Volume 2 - Introductory Chapters

Chapter 7

Description of the Proposed Development – Onshore

7. Description of the Proposed Development – Onshore

Image A7.1 Infrastructure of the proposed development – not to scale (Source: Arup) (Replacing Image 7.1 of the 2024 EIAR)

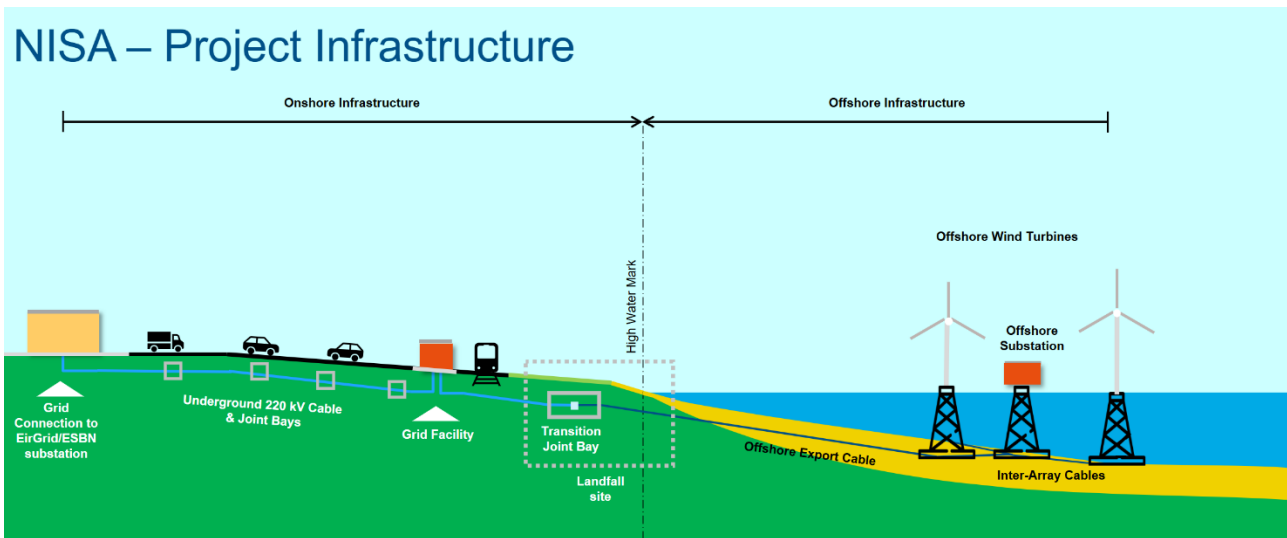
The only change required to Section 7.1 in Chapter 7 of the 2024 EIAR is in relation to Image 7.1. The image, which presented wind turbine generators (WTGs) with monopiles, has been updated to show the WTGs with jacket substructures and suction bucket foundation and to remove the previous depiction of an ownership boundary, as this aspect is not relevant to the graphical illustration of the proposed development.
